DEVELOPMENT CONSENT  
Development Consent No. 1510875  
18 DEC 2014  
SUTHERLAND SHIRE COUNCIL

REVISIONS TO ADDRESS DEFERRED COMMENCEMENT CONDITIONS

PROJECT STATUS  
APPLICATION FOR DEVELOPMENT  
PROPOSED RESIDENTIAL UNIT DEVELOPMENT

ADDRESS  
10-14 MOANI AVE  
GYMEA  
CLIENT  
I J NORMAN NOMINEES Pty Ltd

**NORTH & SOUTH ELEVATIONS**

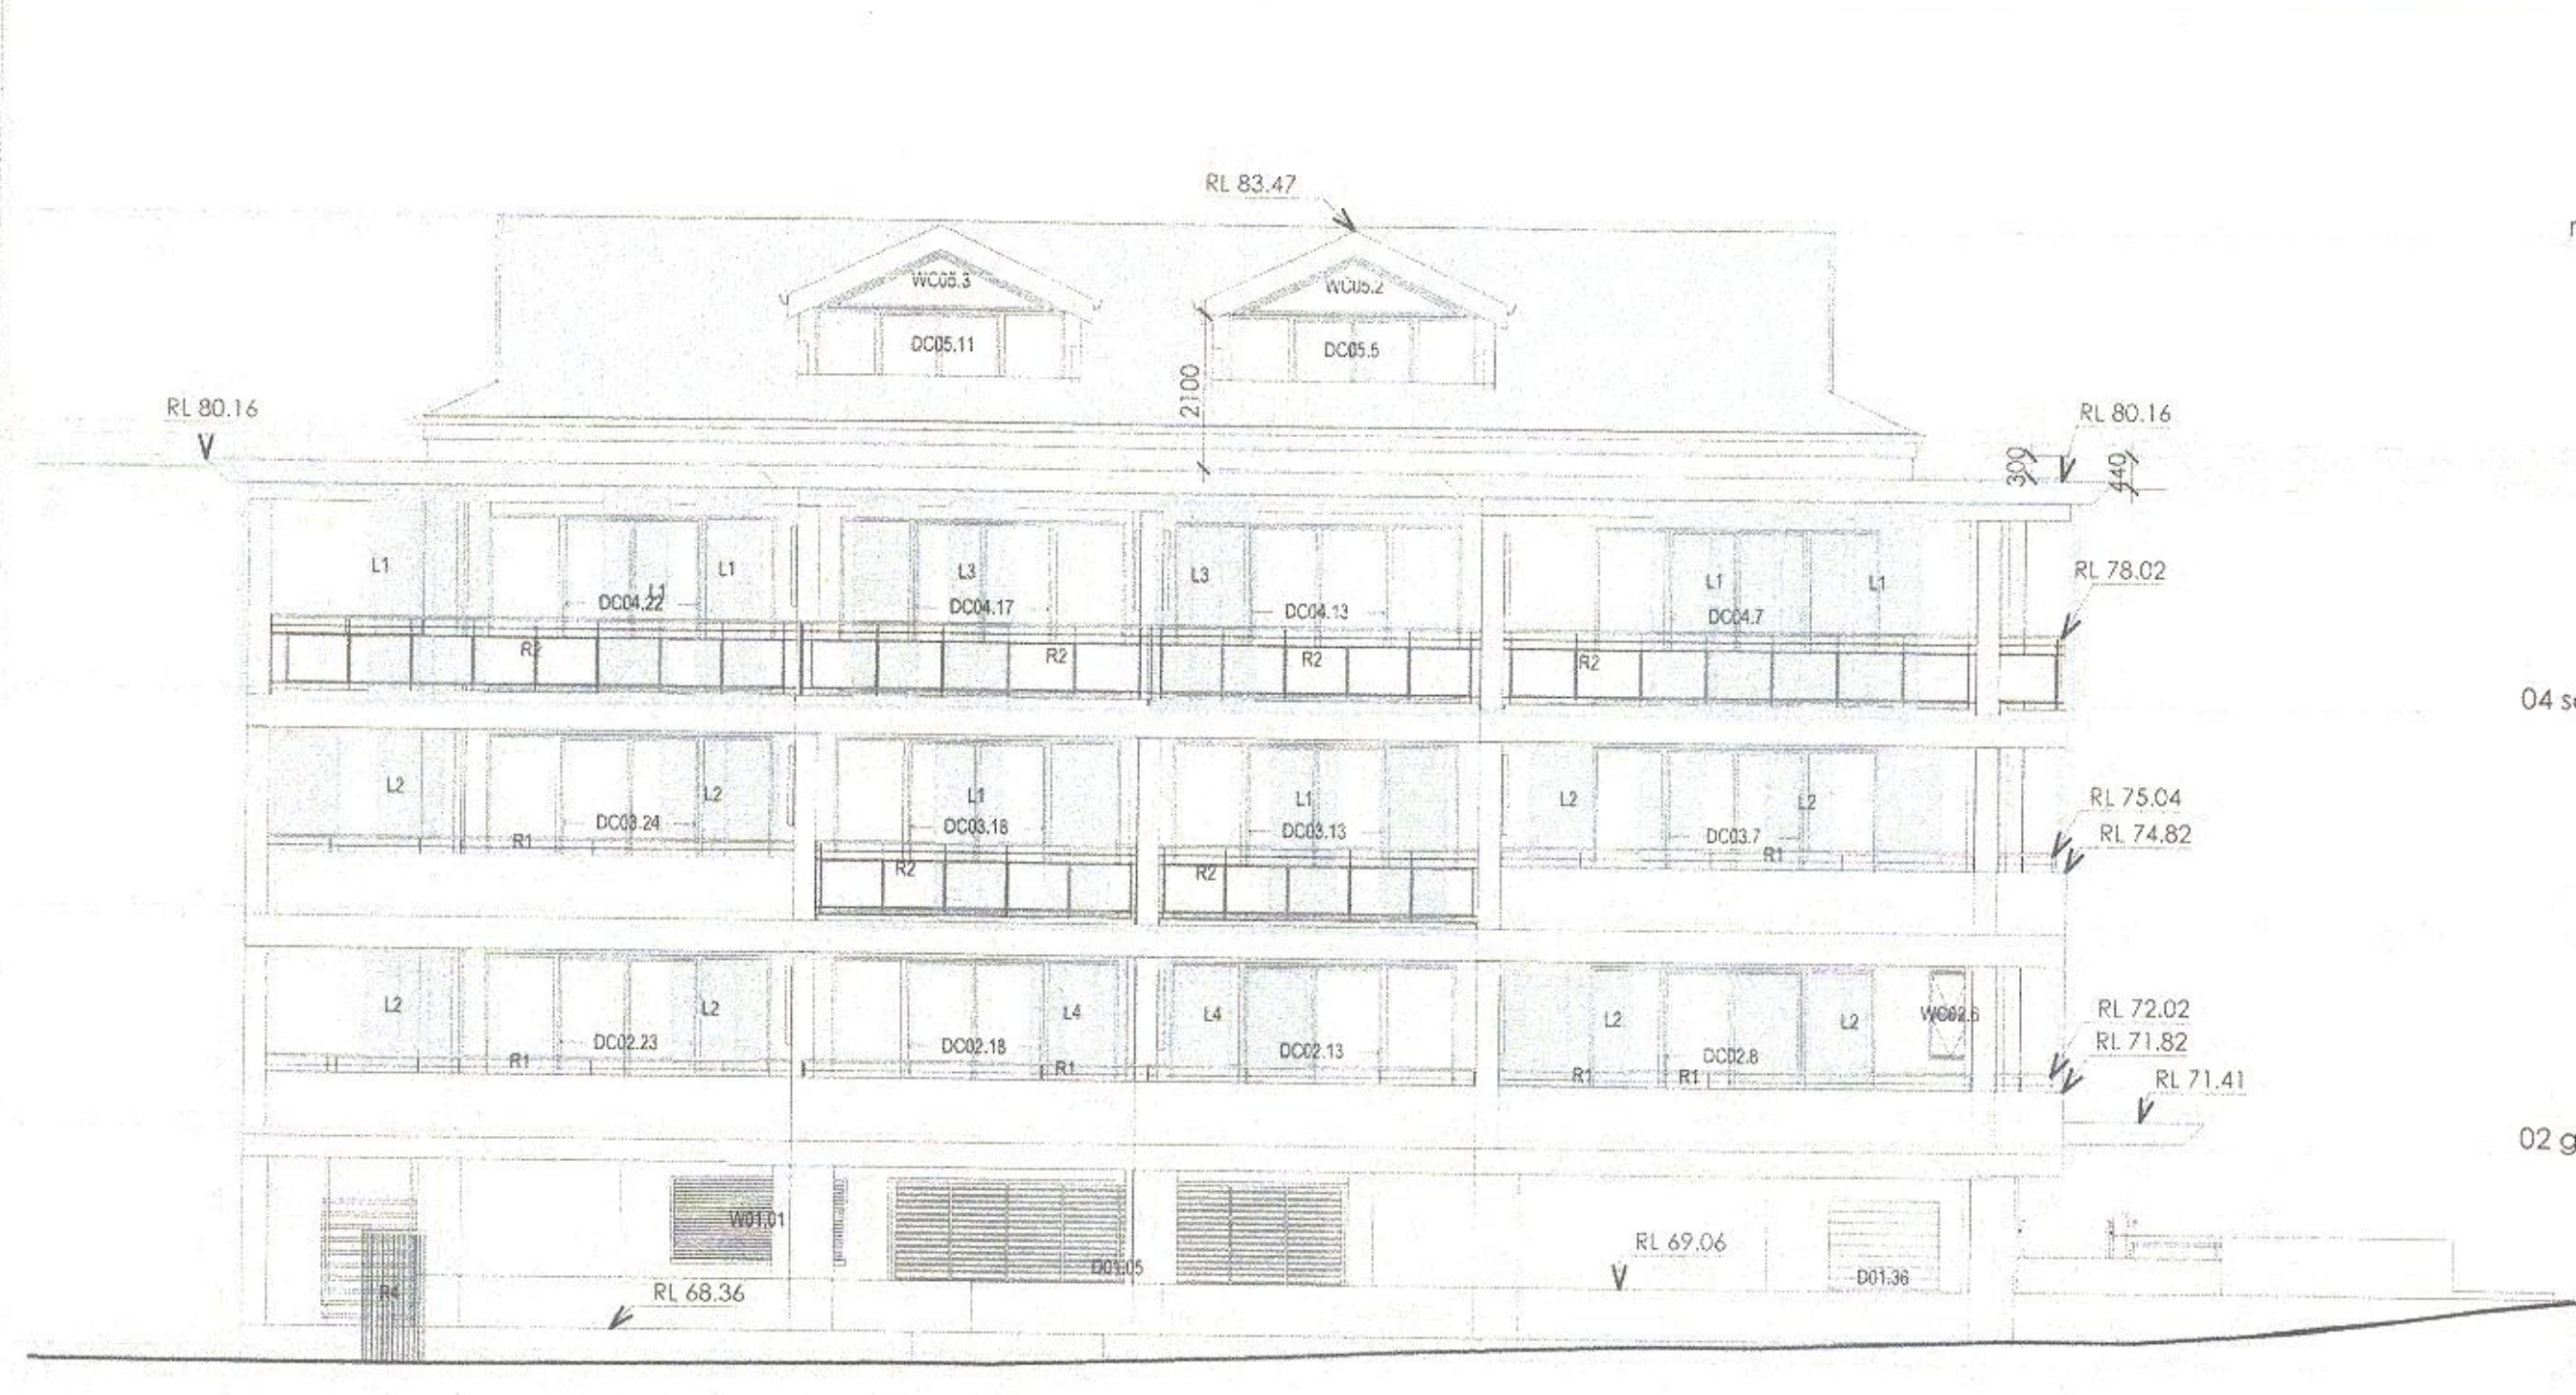
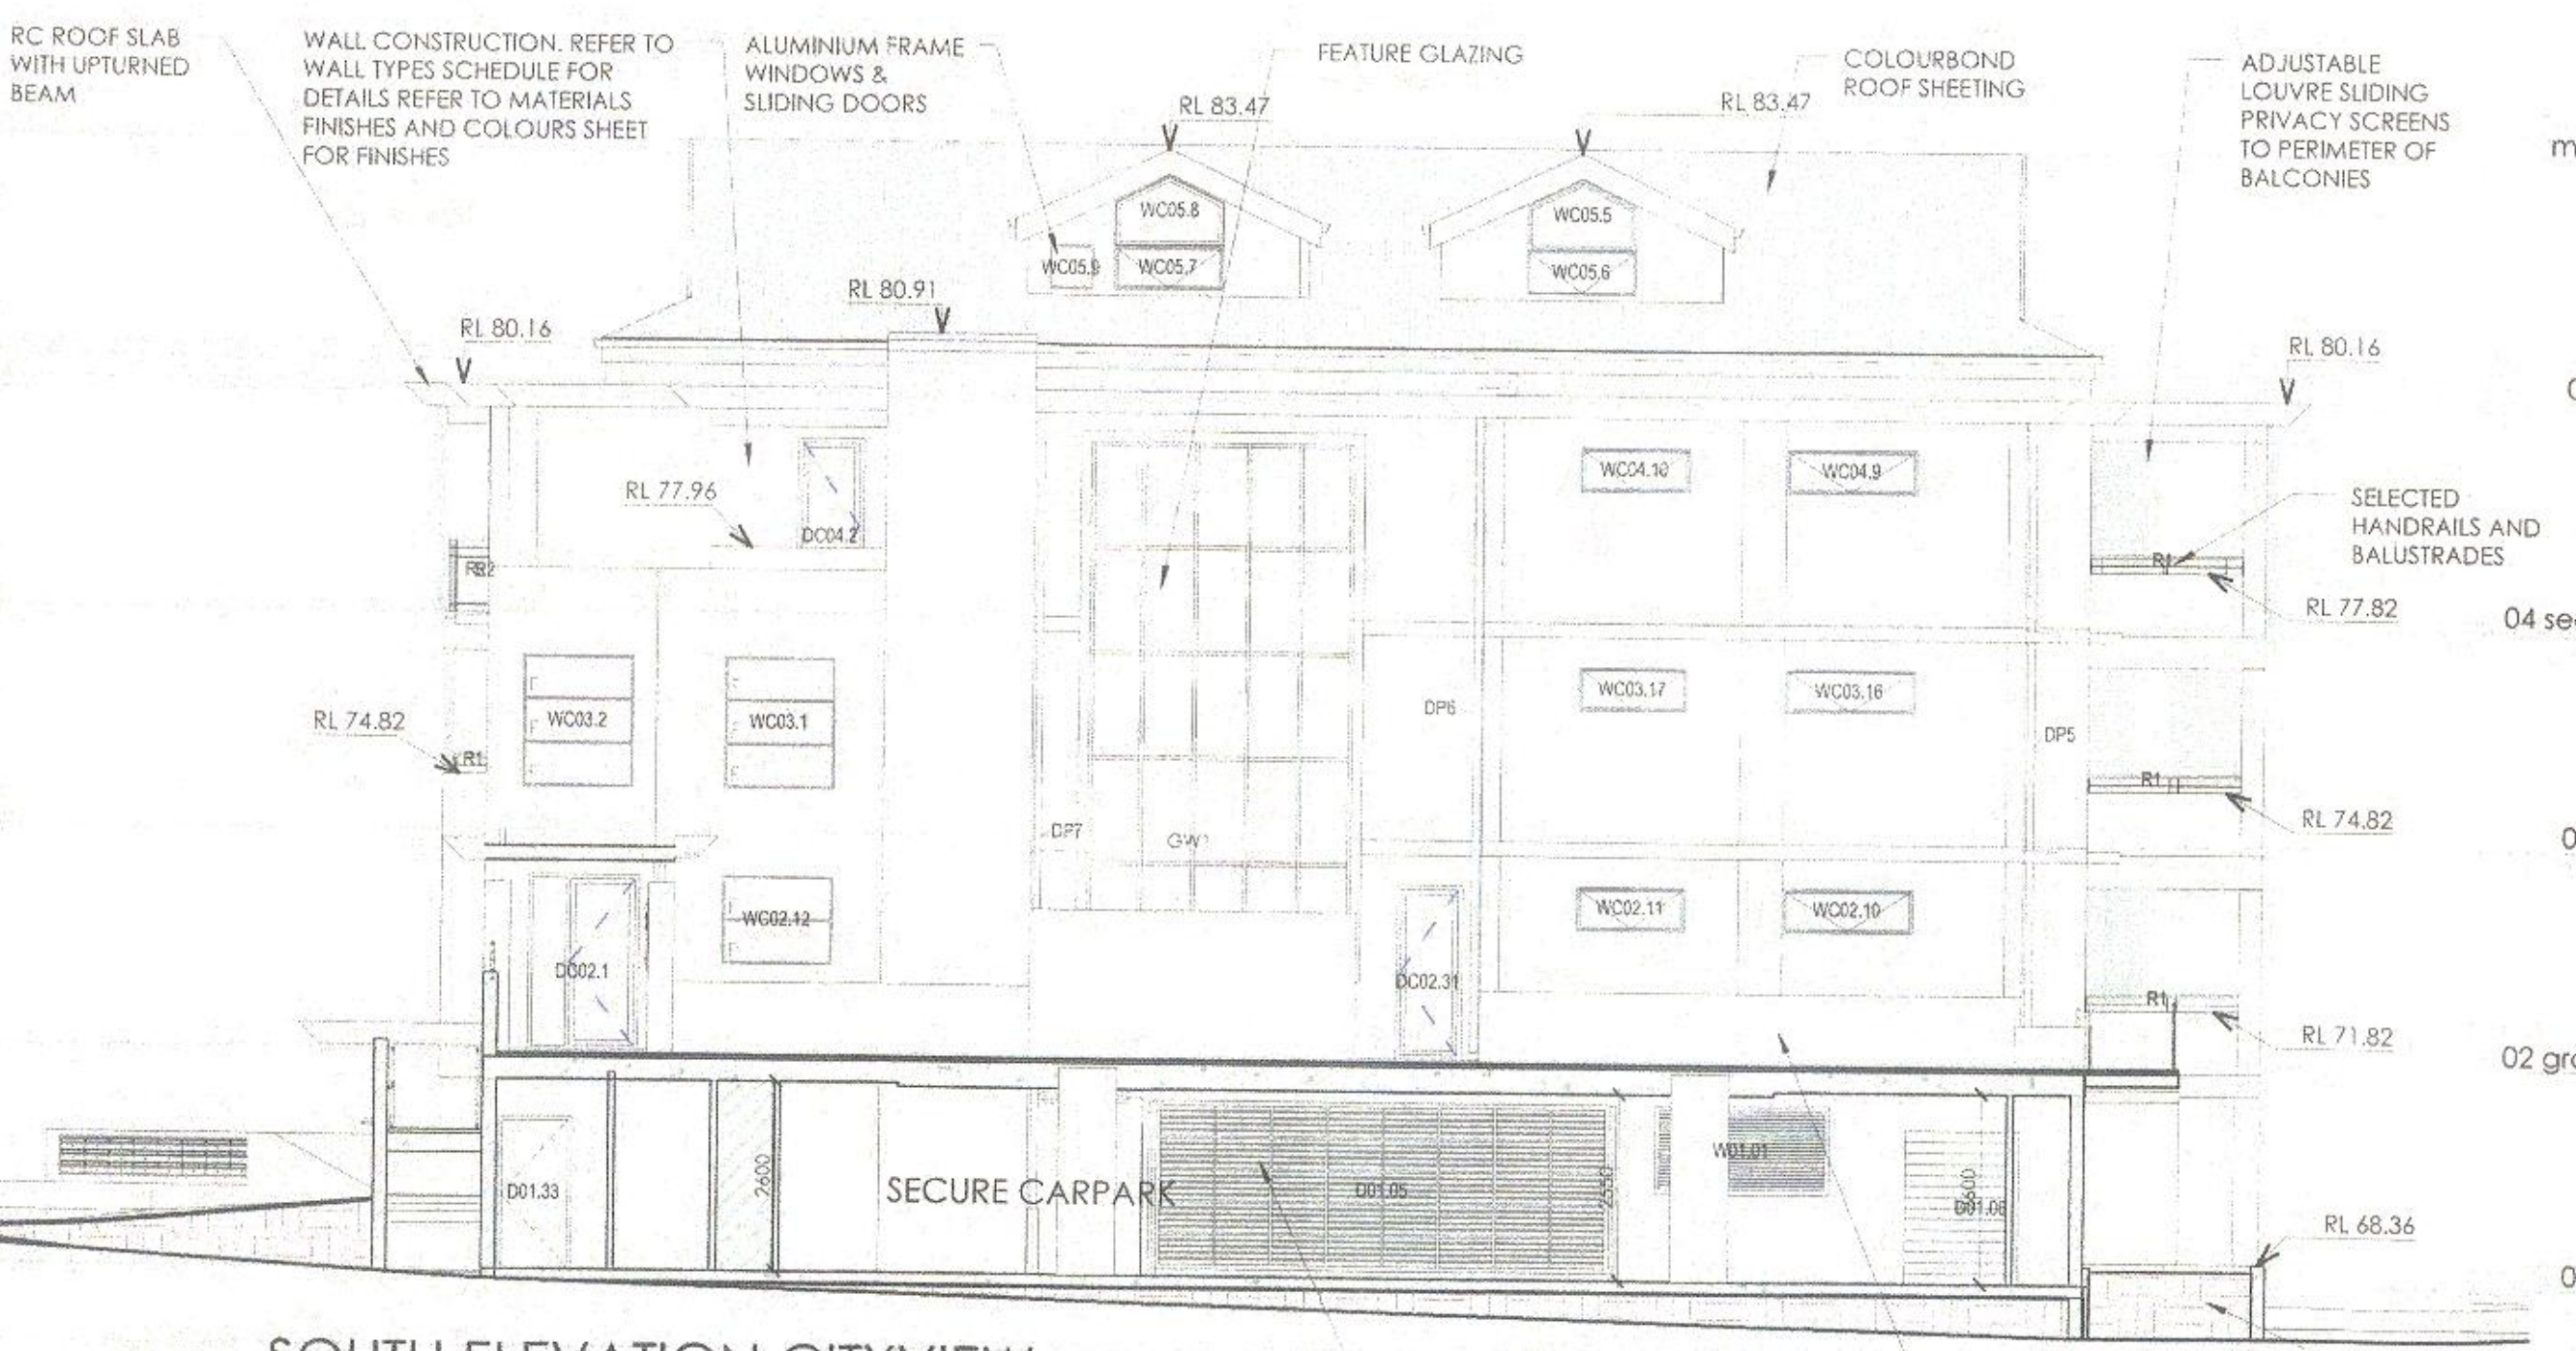
**Division of 2 additional accessible carpark spaces.**  
An application to modify the development consent has been lodged to remove this condition, as it was included in the consent in error.

**Relocation of carpark access to ensure pedestrian safety around L2.**  
The secure carpark has been redesigned. The space around the lift tower, the adjacent carpark L2, there is now adequate space for maneuvering around the carpark space. The inclusion of a barrier at the entry of the lift tower ensures pedestrian safety. The revised carpark design has been certified by Accessible Building Solutions (ABS) in accordance with the Conditions 24, 41 and 42.

**Relocation of Pedestrian entry.**  
The design of the entry has been modified in accordance with the preliminary plans produced at the JNH meeting, but with further modification in order to meet the needs contained in Council's landscape design, including additional walkway to meet the lift landing at the required level design level. The design of the pedestrian entry has been certified by Accessible Building Solutions (ABS) in accordance with the Conditions 24, 41 and 42.

**Extension of carpark level.**  
The path and stairs have been relocated to be adjacent to the podium, and landscaping extended adjacent to the area.

**Extension of carpark level.**  
The carpark level has been amended to show a darker colour to the carpark level.

**Extension of podium level.**  
The podium on the podium level has been extended to provide covered access between the Cityview and Parkview buildings.

**Widened Courtyards P12, P13, P14, P15.**  
The podium level courtyards have been extended to 1m depth. Adjustable louvre privacy screens have been included on the northern wall of each courtyard to 1.8m high. Concrete garden planters have been provided in the courtyard area in front of each courtyard.

**Widened access to eastern external stairs.**  
The eastern external stairs have been widened to align with path through podium terrace.

**Widened access to eastern external stairs.**  
The upper level of these apartments have been redesigned to locate the staircases between the bedroom and study, as shown on plans as tabled at JNH meeting.

**Relocation of carpark level and lift.**  
The carpark level and lift tower have been redesigned to align with the carpark level and ground floor level above and the approach to lift 2 have been redesigned as tabled at the JNH meeting, with minor amendment to ensure accessibility. The design has been approved by Accessible Building Solutions (ABS) in accordance with the Conditions 24, 41 and 42.
